January 16, 2020
BOARD OF COUNTY COMMISSIONERS
ORANGE COUNTY, FLORIDA
ADDENDUM NO. 2 / IFB Y20-729-RM
ORANGE COUNTY INTERNAL OPERATIONS CENTER I RESTROOMS RENOVATIONS
REVISED BID OPENING DATE: January 23, 2020

Project:
INTERNAL OPERATIONS CENTER - I
RESTROOM UPGRADES - ALL FLOORS
450 E. SOUTH STREET
ORLANDO, FL 32801

Sheet Title:
ENLARGED FLOOR PLAN
& ELEVATIONS

A08.01B

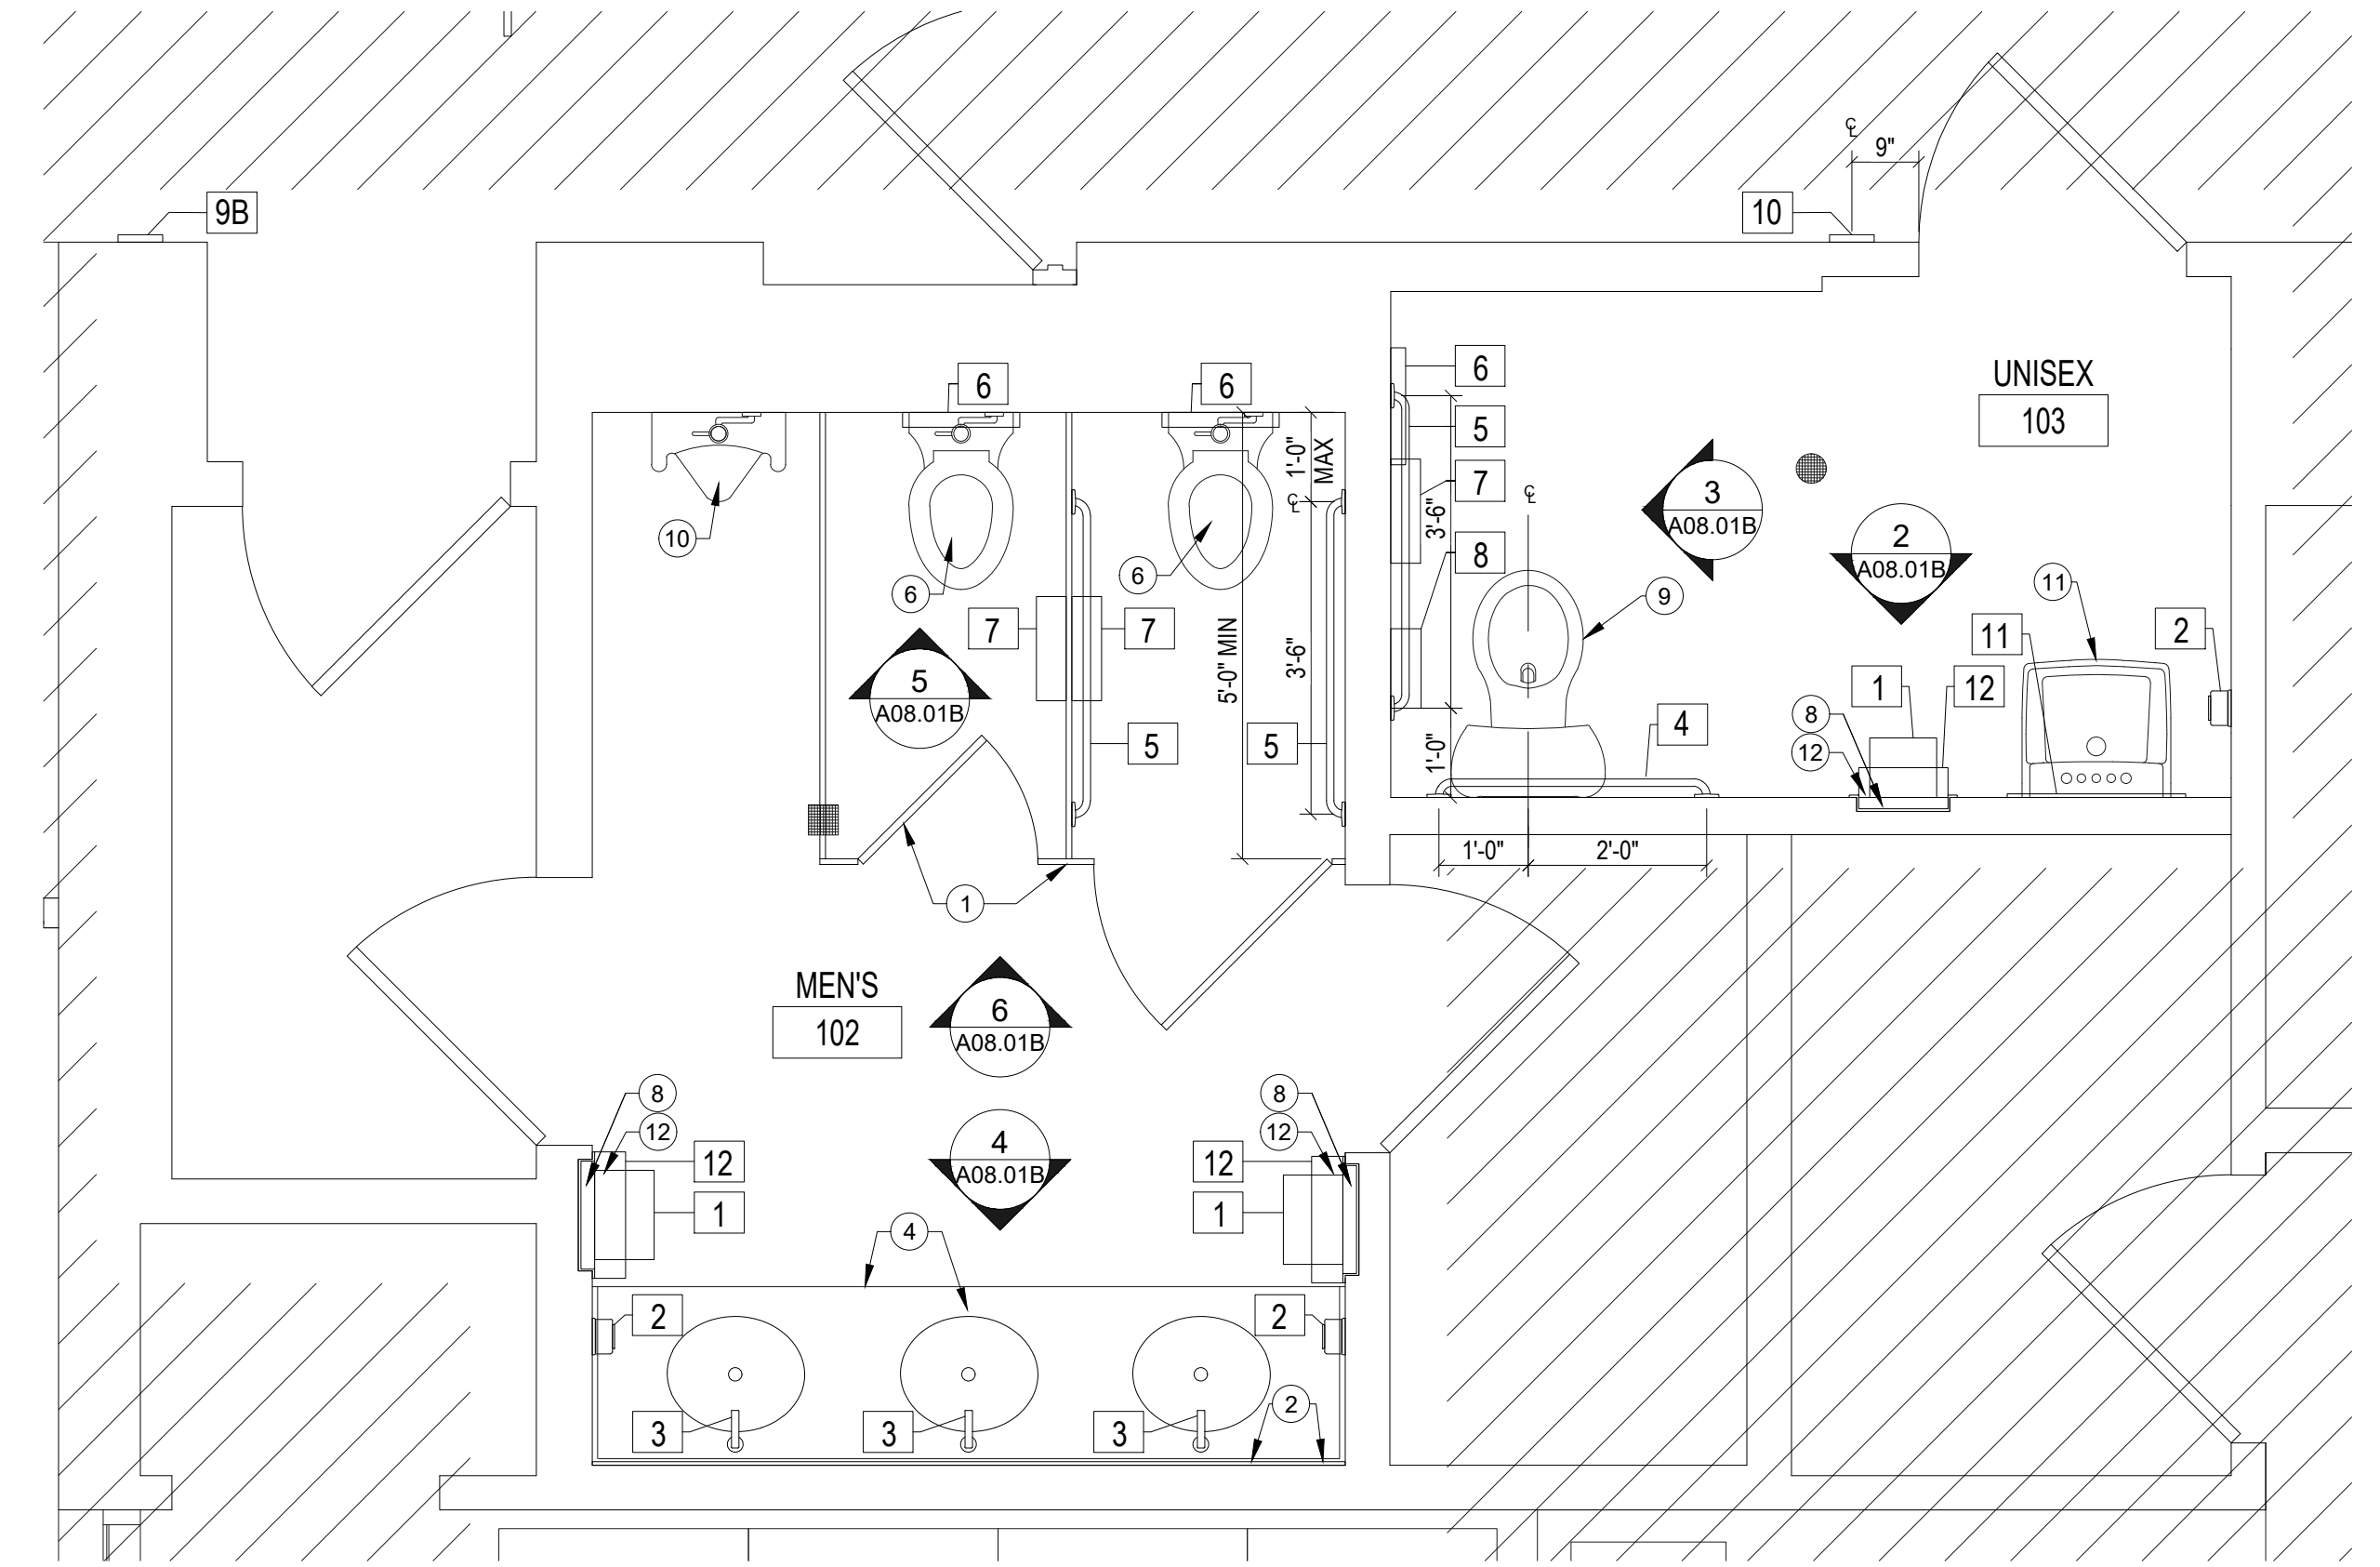
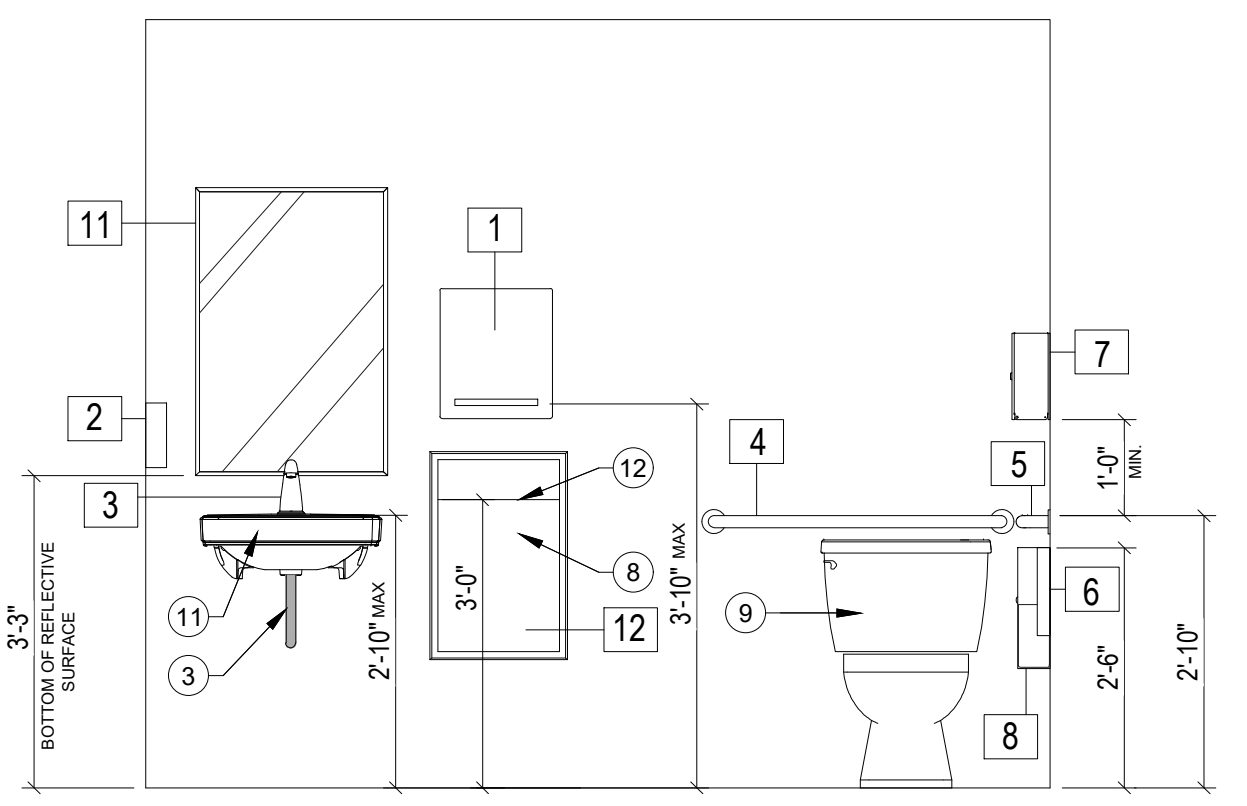
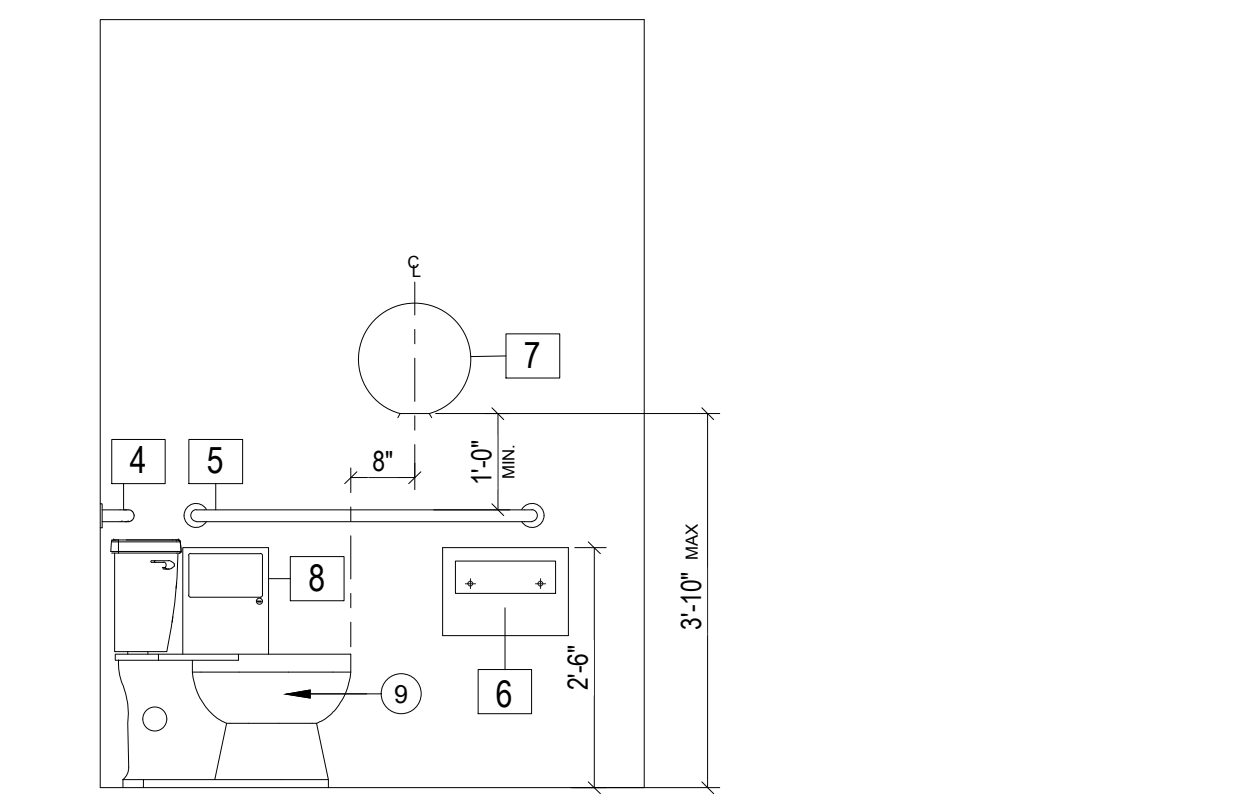
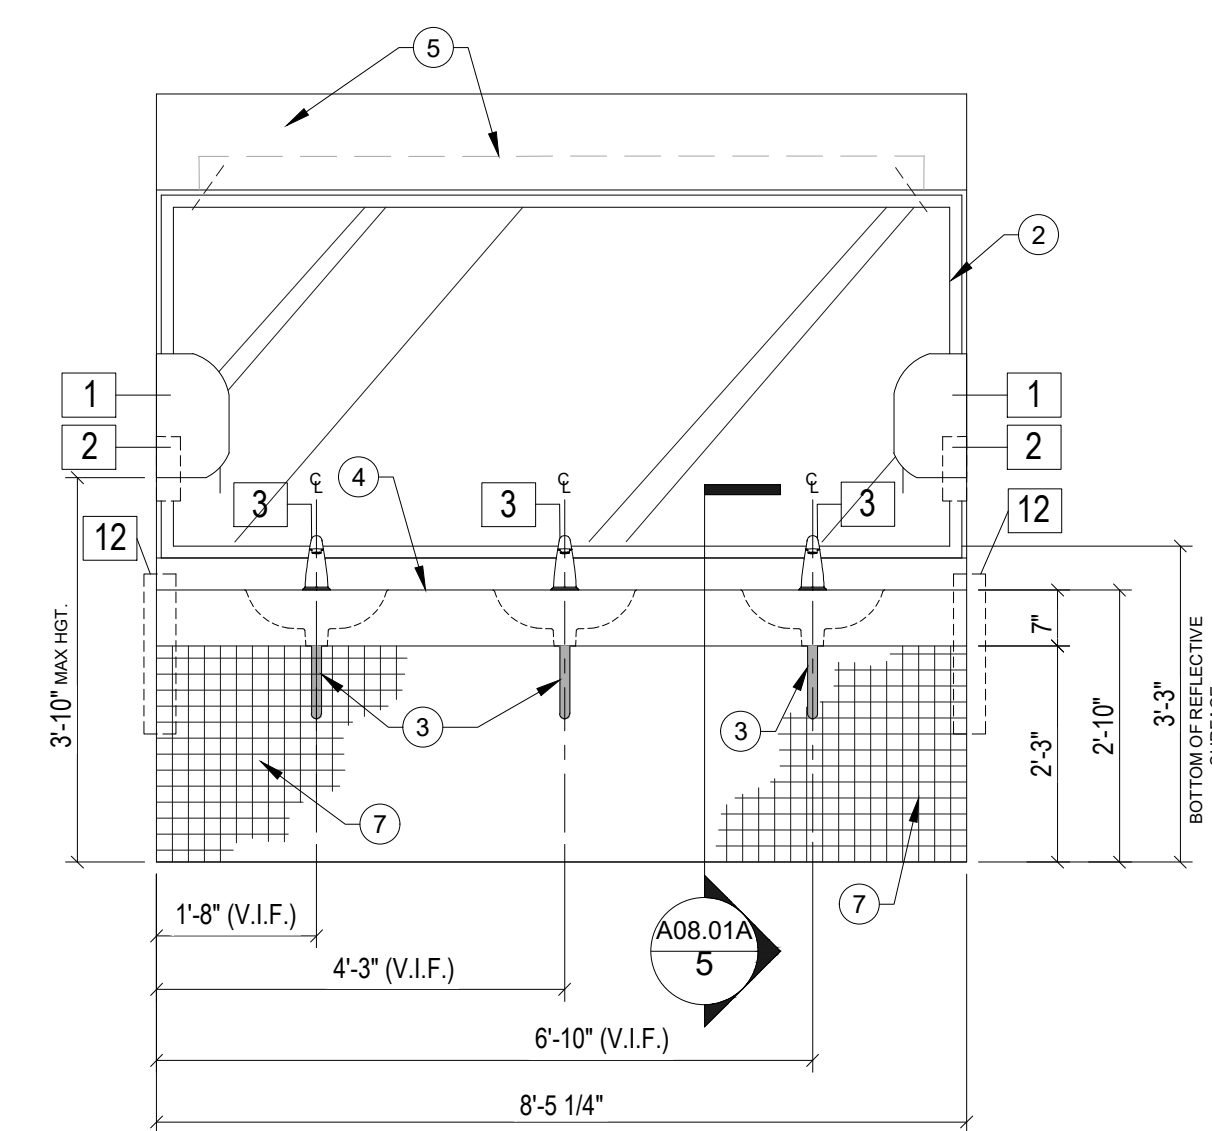
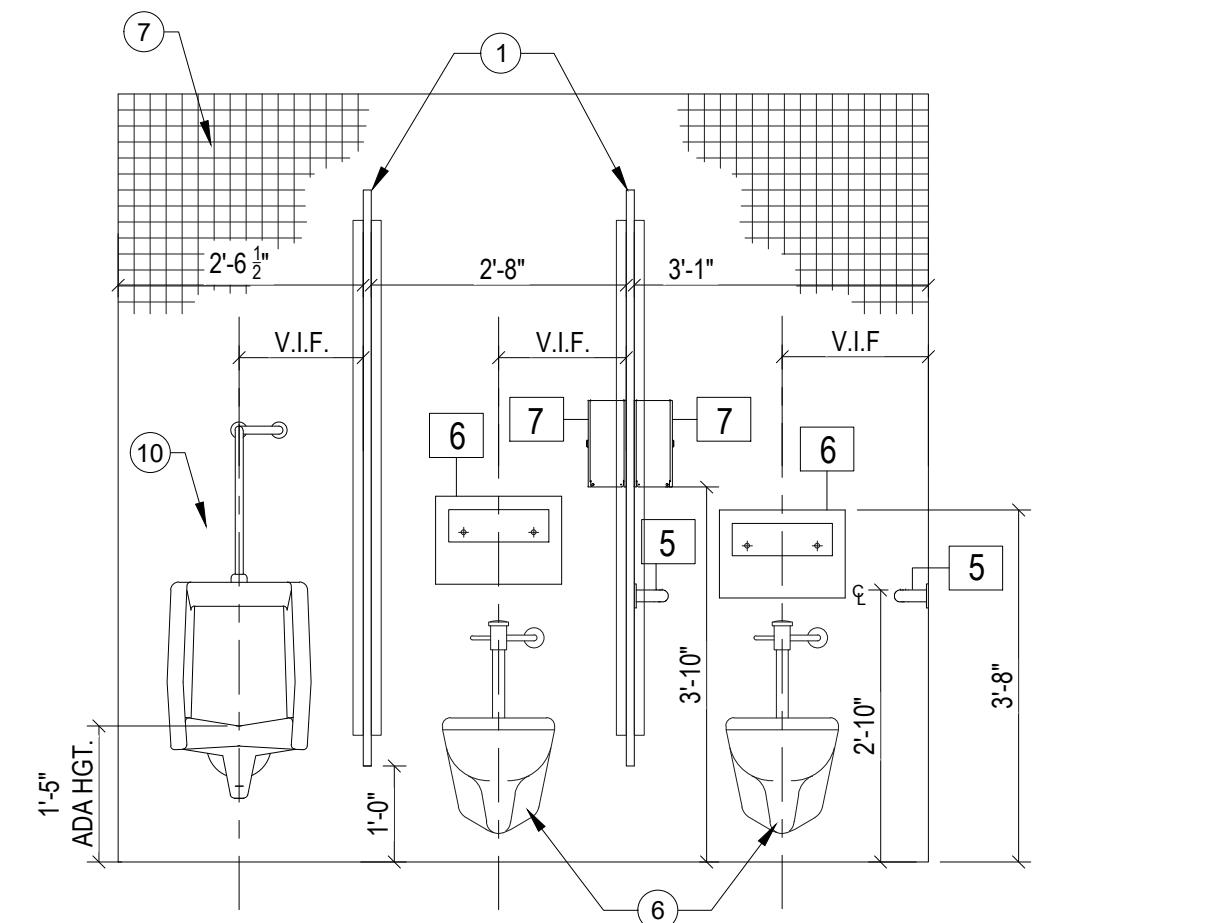
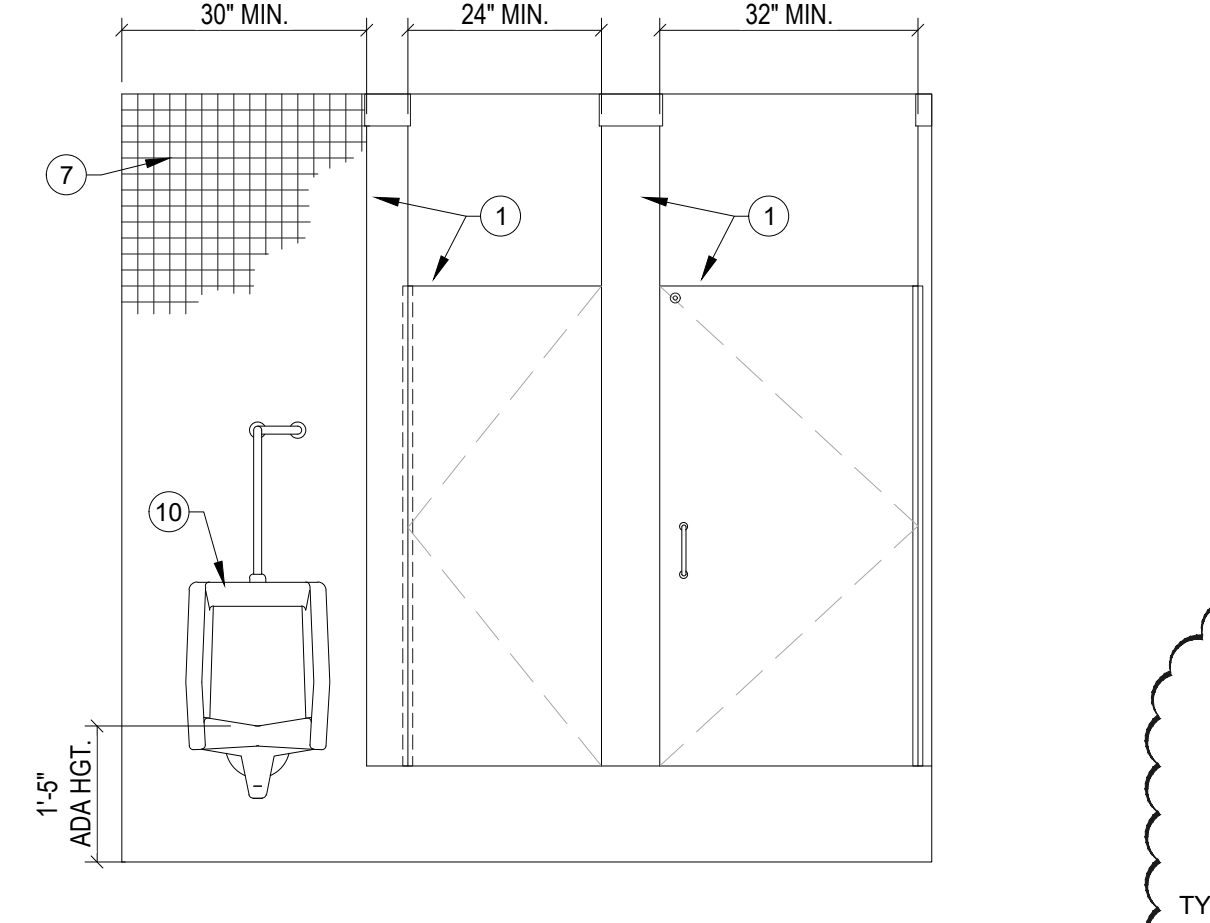
- 1. There is a discrepancy in reference to the toilet partitions installation: According to the specifications document section 10 2113 the partitions shall be floor mounted and as per the drawings ceiling mounted. (See below cited information) Please provide clarification on which document we should use for installation guide.**

30. Please provide specific details about the signage program for the renovations for all restrooms and floors.

Ceiling mounted partitions, this was requested by Facilities.

Restroom signage information is included in the drawings, see Toilet Accessories Schedule on sheets A08.01A & A08.01B.
